ADA Curb Ramp New Construction Inspection Form (Parallel)

NW Timeric

23885.56

NW Lenux

PARALLEL RAMP (PL)

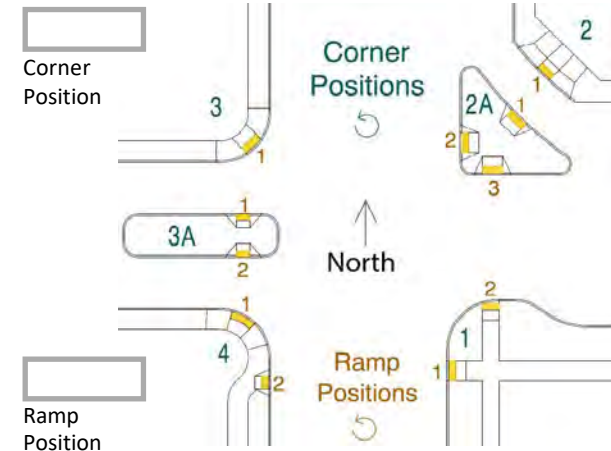
☐ 11.5 $\leq 8.3\%$ ☐ $> 8.3\%$ ☒

11.3 $\leq |5.0\%|$ ☐ $> |5.0\%|$ ☒

7.3 $\leq 2.0\%$ ☐ $> 2.0\%$ ☒

7.1 $\leq 2.0\%$ ☐ $> 2.0\%$ ☒

3.5 $\geq 4.0'$ ☐ $< 4.0'$ ☒

NTD Fails RR 1 and Turn space
